TOWN OF MILFORD

Administrative Review

Date: September 24, 2020
To: Jason Plourde, Chair, Zoning Board of Adjustment
From: Lincoln Daley, Community Development Director
Subject: **Case #2020-25:** San-Ken Homes, Inc., Milford Tax Map 30, Lot 19 – Variance Application.

Street Photo(s) of Subject Property:

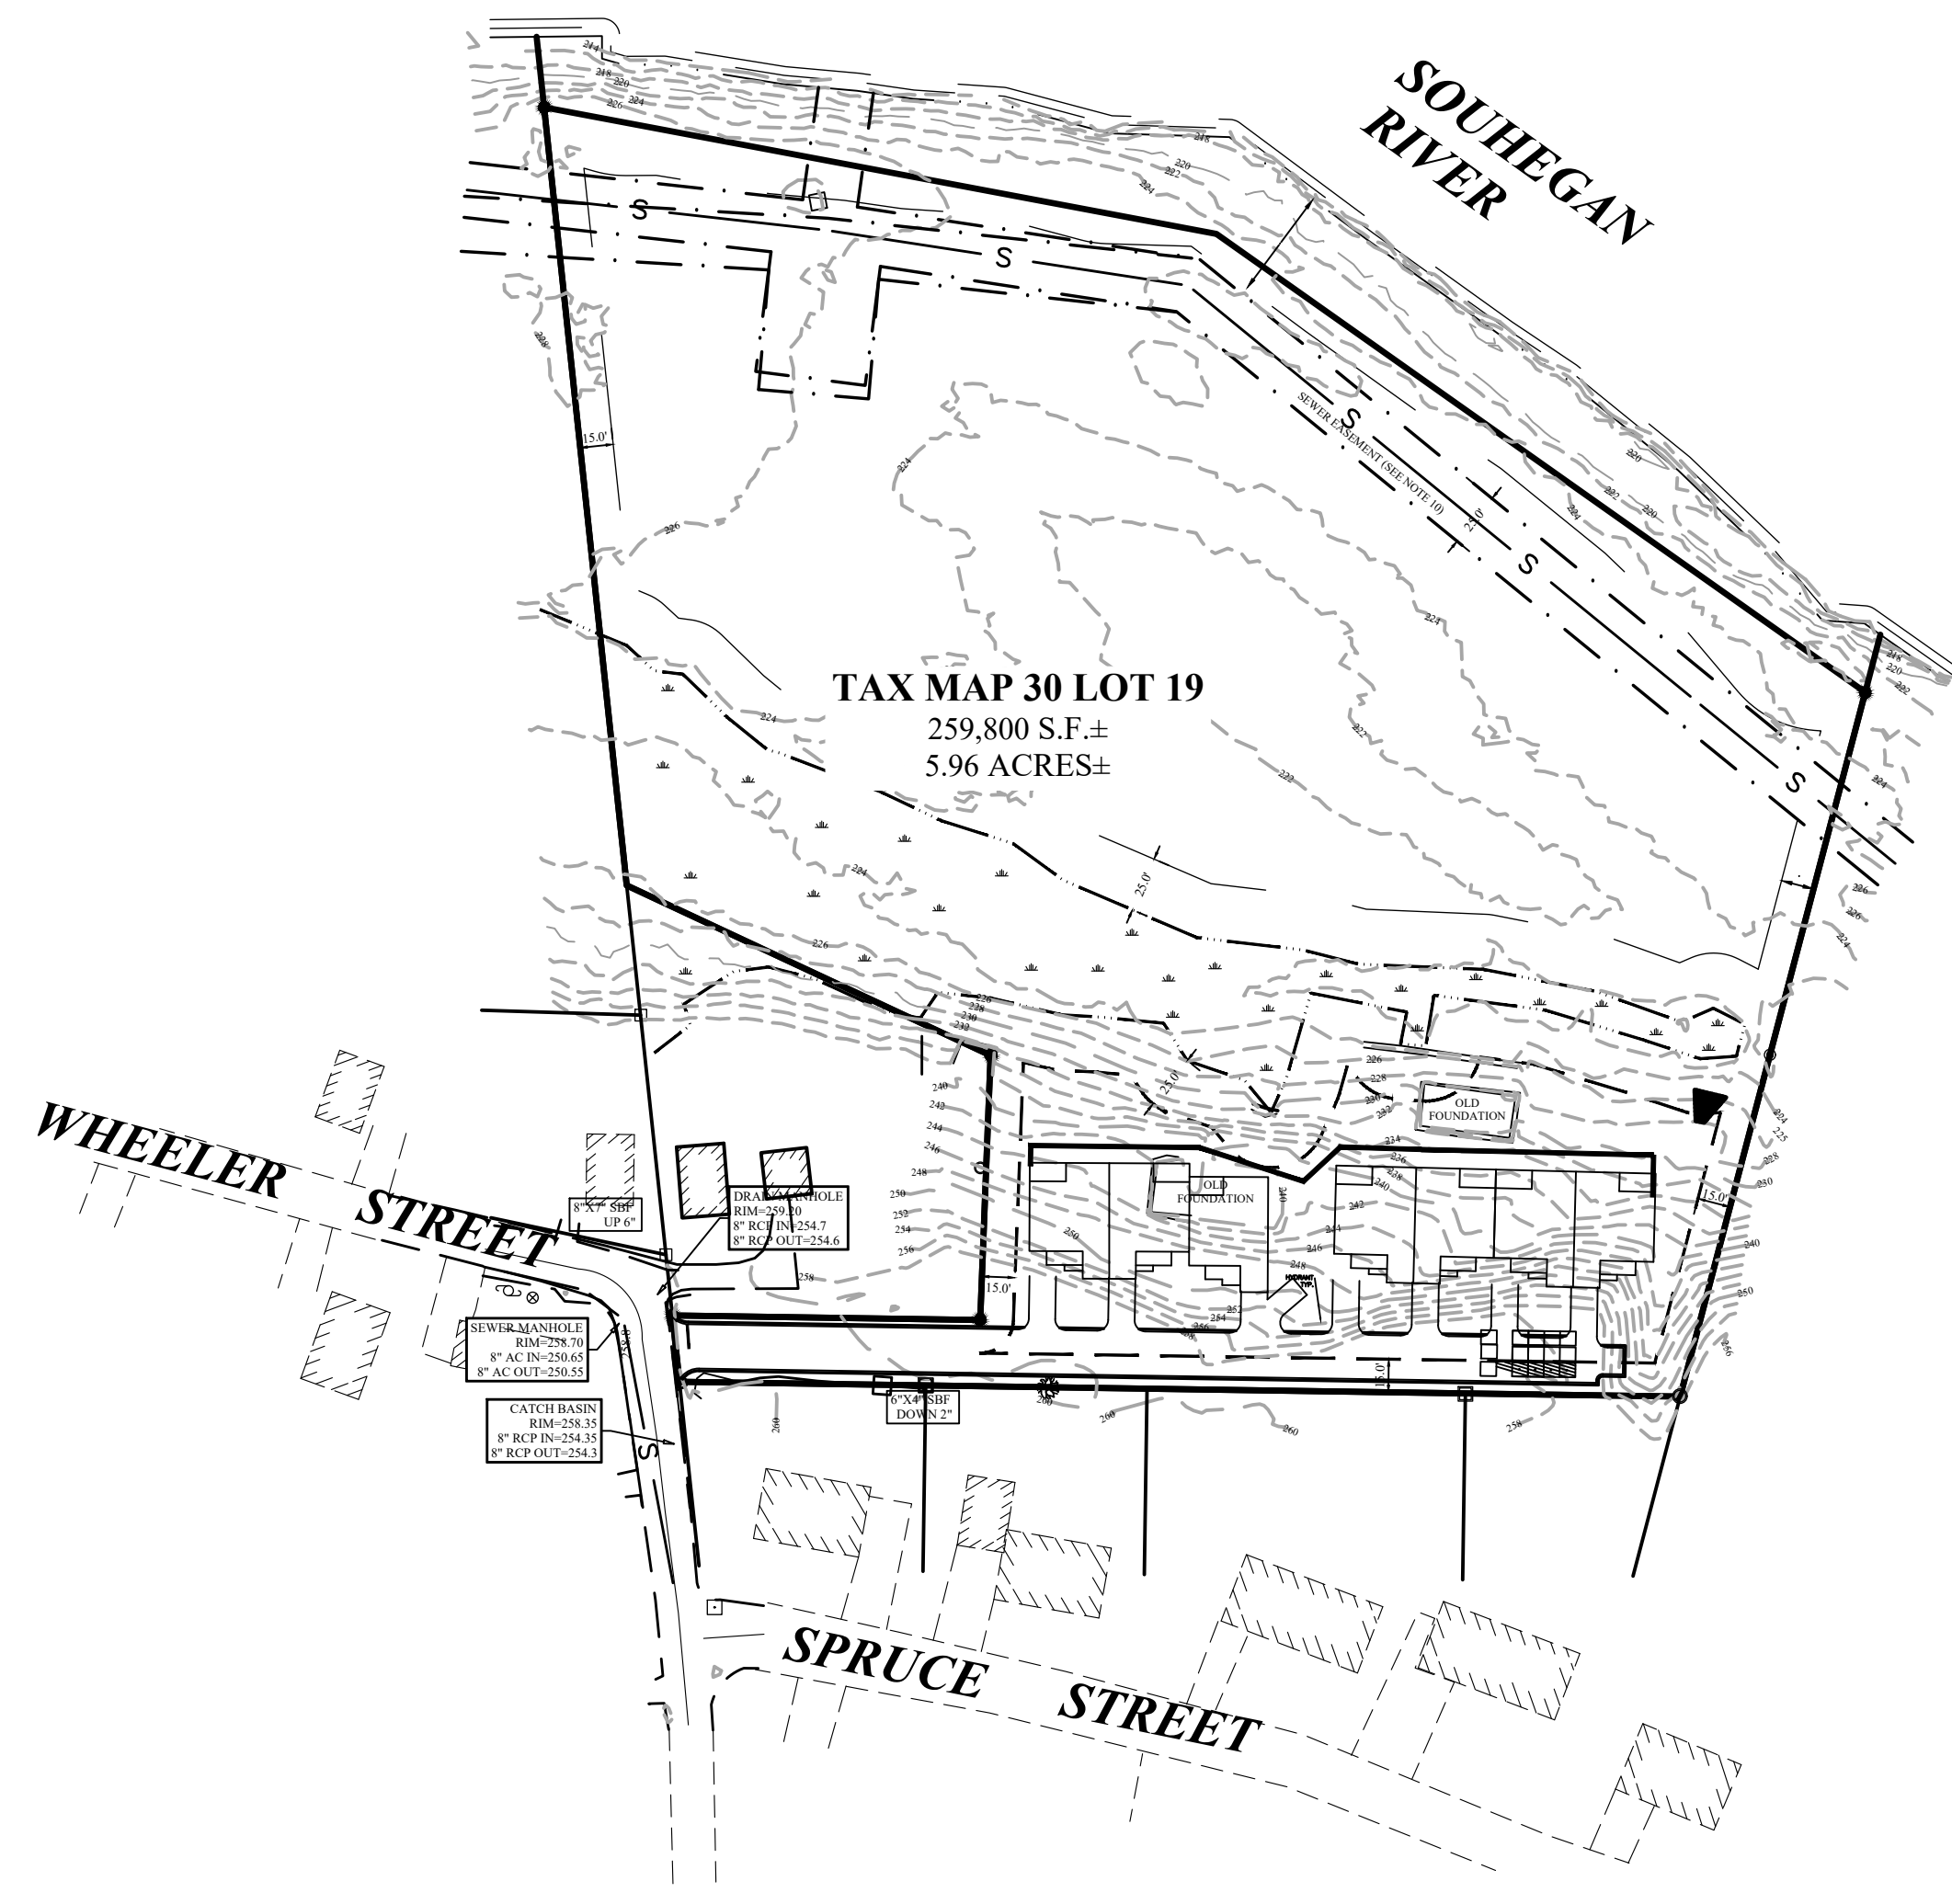
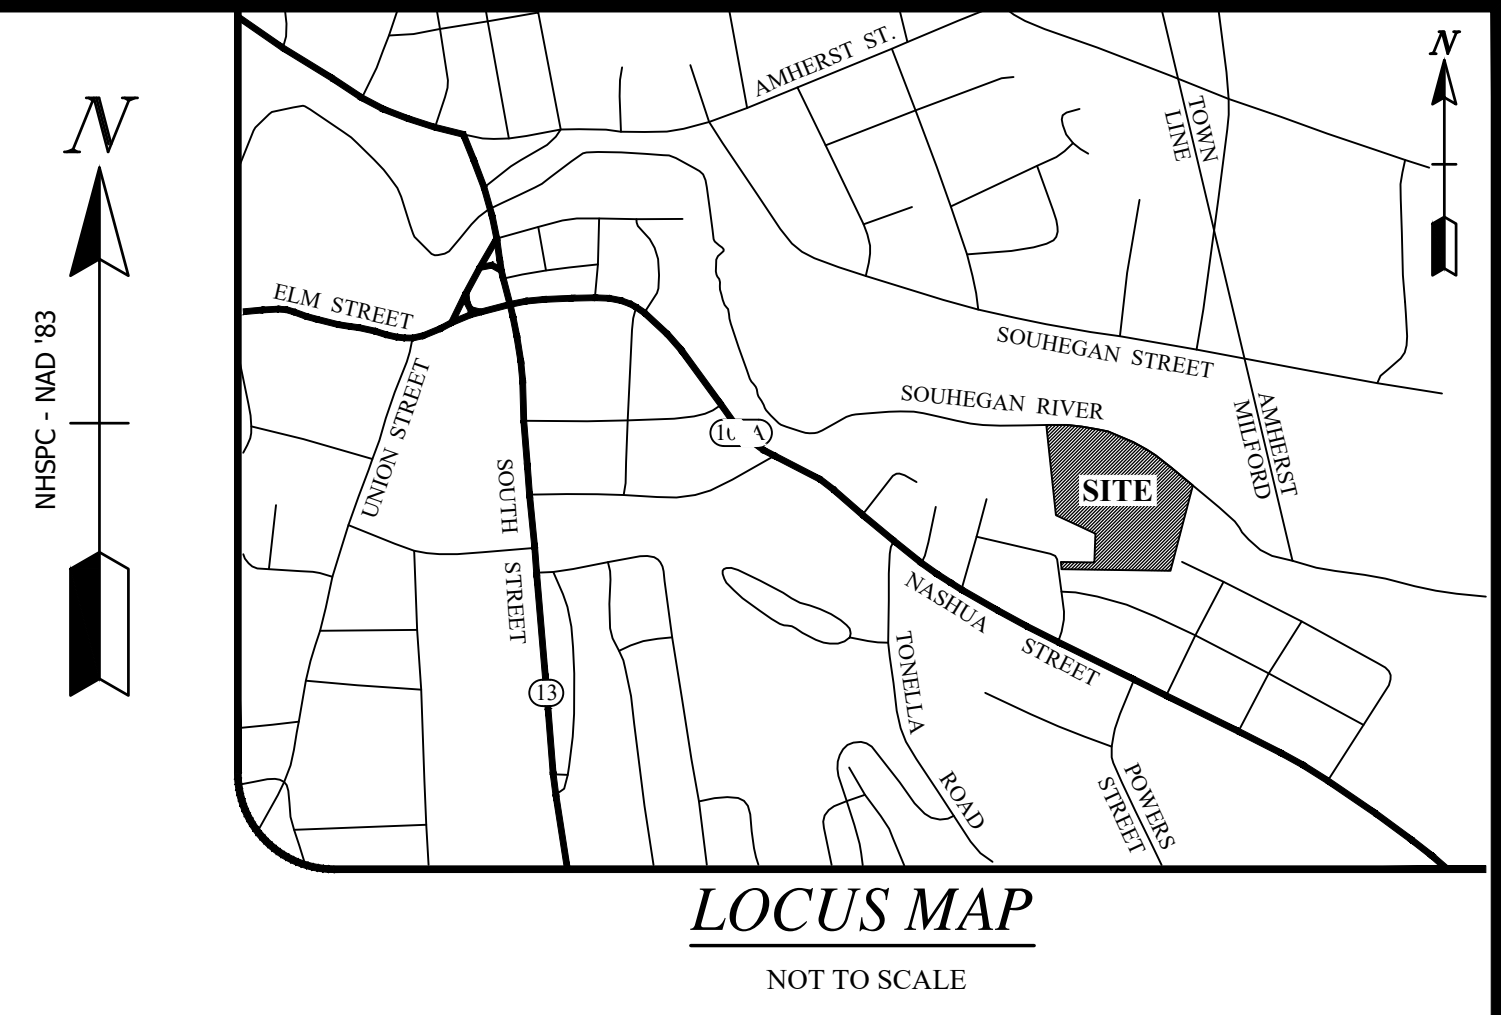
- c. The property contains approximately 30 linear of frontage on Wheeler Street (a Class V roadway).
 - d. The property is situated in an established single, two-, and multi-family residential neighborhood and abuts the Souhegan River to the North.

3. Access to the property would be through the 30 linear feet of frontage on Wheeler Street (a Class V roadway).
4. Said driveway access would require a driveway permit from the Public Works Department and shall meet the driveway standards and regulations. The driveway and development would be subject to a Milford Stormwater Permit.
